Access Compliance Report Public Rights-of-Way (Curb Ramps)

Main Street: CHAUCER_RD Cross Street: KEMPTON_DR Location: NE

ADA ID: RPRK211208123701 Ramp Type: Type 1 - Perpendicular Diagonal Initial Pass/Fail: Fail Overall Compliance: No Severity Score: 2

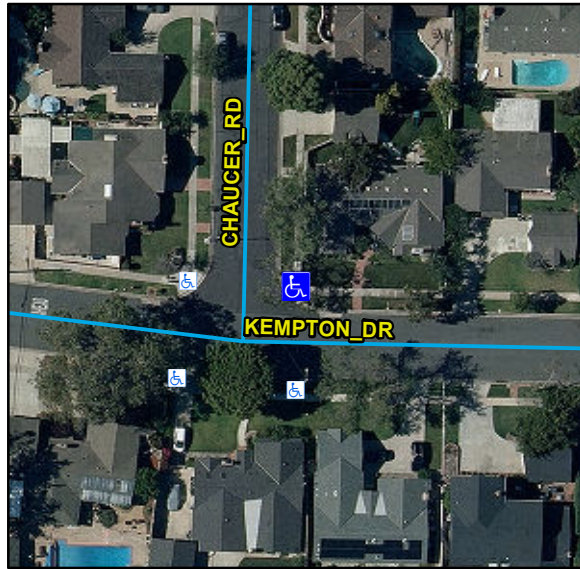
R304.2.2, R204.3, R304.5.3, STD 1115

Remove & Replace Curb Ramp With Two New Directional Ramps or Equivalent.
